INTERNATIONAL STANDARD ISO 14738:2002

TECHNICAL CORRIGENDUM 2

Safety of machinery — Anthropometric requirements for the design of workstations at machinery

Page 7, Table 3

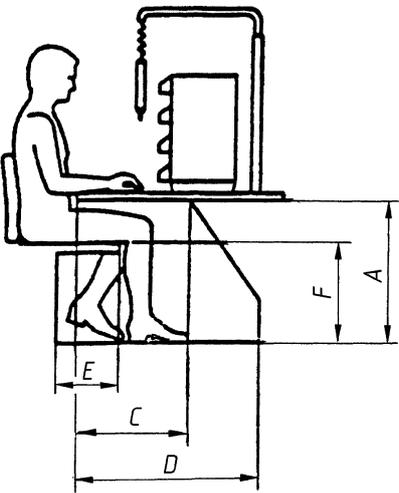
Insert the following text under the third illustration from the top in the “Posture” column:

“Such postures should only be maintained for short periods of time.”

Table 5 — Sitting, space requirements for legs and feet

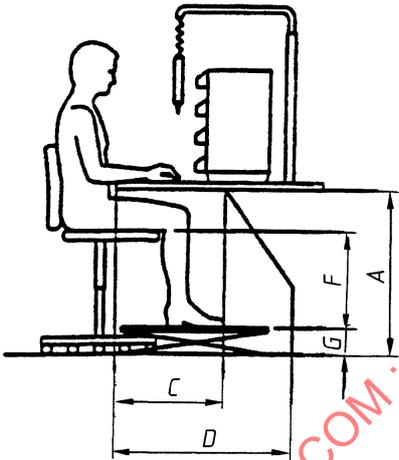
Replace Table 5 by the following table.

Posture	Notation	European value ^a mm	Explanation of measurements
<p>Working surface height, <u>adjustable</u></p> 	A	820 495	Leg space height, sitting, adjustable $A_{max}=h_{16}(P95)+b_{18}(P95)+x_3$ $A_{min}=h_{16}(P5) + b_{18}(P5)+x_1$
		720	not adjustable: $A=h_{16}(P95)+b_{18}(P95)+x_1$
	B	790	Foot and leg space, width $B=a_{17}(P95)+y$ (width for access to fixed seats see "B" in table 6)
	C	547	Leg space, depth at knee height $C=c_1(P95)-b_{15}(P5)+z_1$
	D	882	Leg space depth for feet $D=c_1(P95)-b_{15}(P5)+c_2(P95)+z_2$
	<p>Working surface height, <u>not adjustable</u></p> 	E	285
F		535 370	Seat height above foot support, adjustable $F_{max}=h_{16}(P95)+x_1$ $F_{min}=h_{16}(P5)+x_1$
G		0 165	Footrest height (adjustable - only needed for non-adjustable working surface height) $G_{min}=0$ $G_{max}=h_{16}(P95)-h_{16}(P5)$
<p>NOTE 1 For allowances, x, y, z see Clause 5.</p> <p>NOTE 2 For an explanation of notations see Annex A.</p>
